Our Ref: 14-14/L000190 CRC Ref: CA 604/2014 (437880)

Date: 13 July 2015

RE: RESPONSE TO INFORMATION REQUEST PURSUANT TO SECTION 278 OF THE SUSTAINABLE PLANNING ACT 2009 IN RELATION TO AN APPLICATION FOR DEVELOPMENT PERMIT FOR MATERIAL CHANGE OF USE FOR 'MULTI UNIT HOUSING' AND RECONFIGURATION OF A LOT (1 INTO 2) ON LAND AT 6 MUDLO STREET, PORT DOUGLAS, DESCRIBED AS LOT 915 ON PTD2092

Figure 1 Site Plan

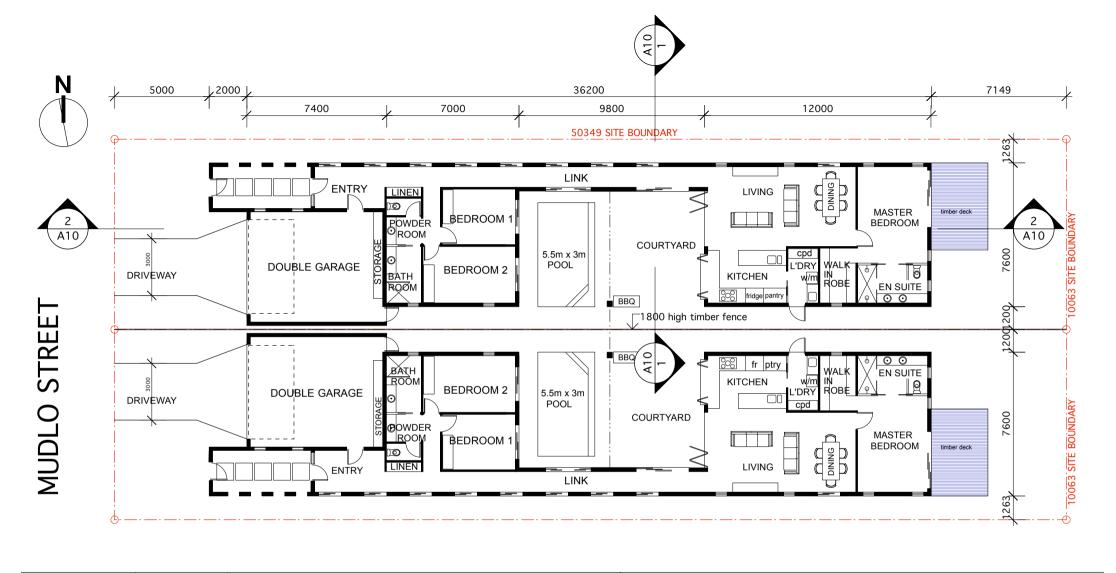
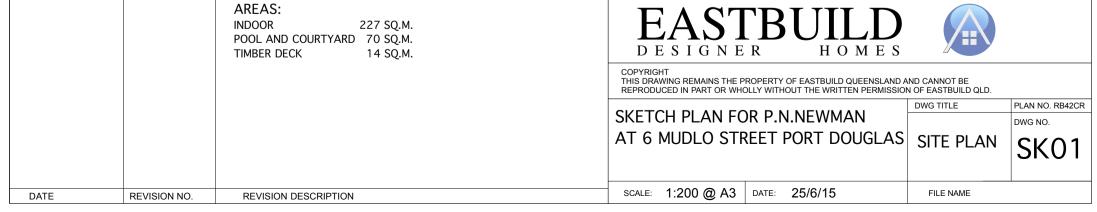
In relation to setbacks, a dispensation of only 0.237m is sought, which is considered to be very minor. In order to address council's concerns about building bulk in relation to neighbouring properties, the Site Plan and Floor Plan (**Figures 1 & 2**, respectively) have been revised to provide for rear access along the proposed internal boundary to ensure that the external boundaries are wholly available for landscaping. Further, an indicative landscape plan has been prepared (**Figure 3**) which shows what landscaping is proposed along these boundaries.

The Site Plan has been revised to reduce the width of cross-overs to 3m at the property boundary.

Figure 4 Elevations

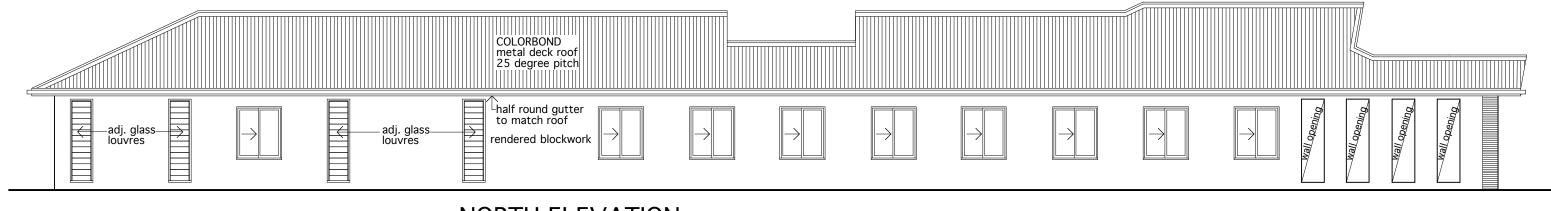
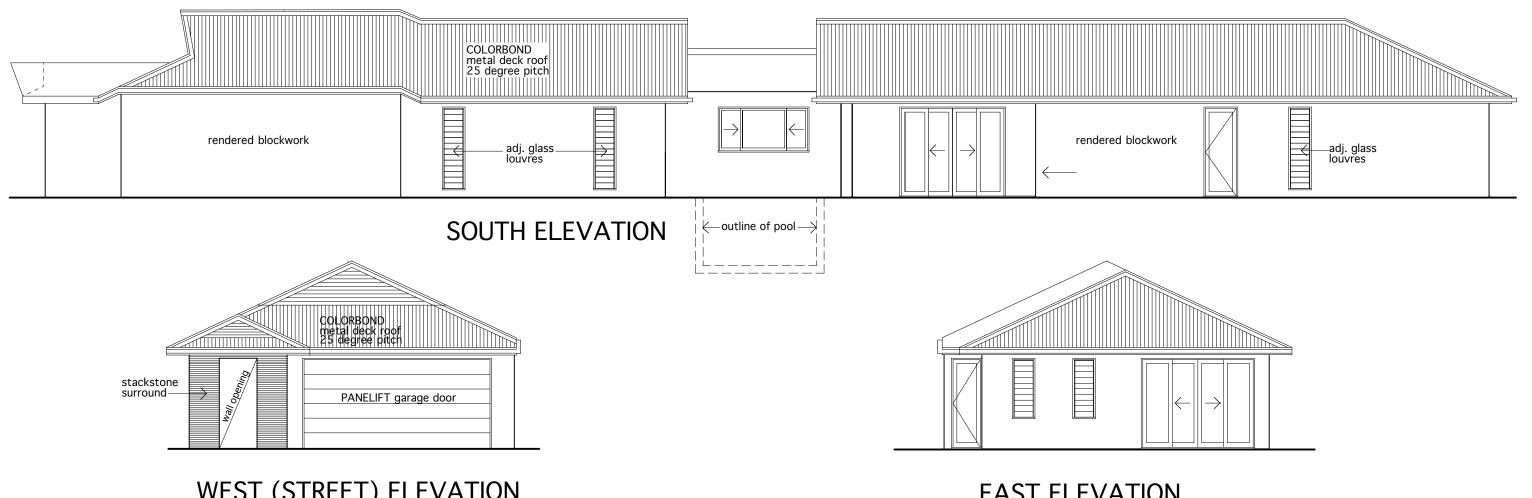
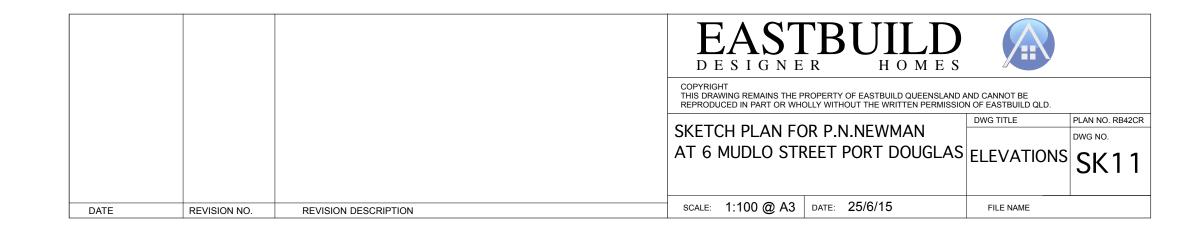
1. Please provide details of how the development incorporates building design features/architectural elements and corresponding plot ratio bonuses.

3. Please provide elevation plans with building elements, exterior colours, textures and materials.

As noted above, plot ratio is compliant with planning scheme requirements. Notwithstanding, revised Elevations, Sections and 3D Perspectives (**Figure 4, 5 & 6**, respectively) have been prepared which show variation to the roof form and other architectural features.

Elevations, Sections and 3D Perspectives are included as Figure 4, 5 & 6, respectively.
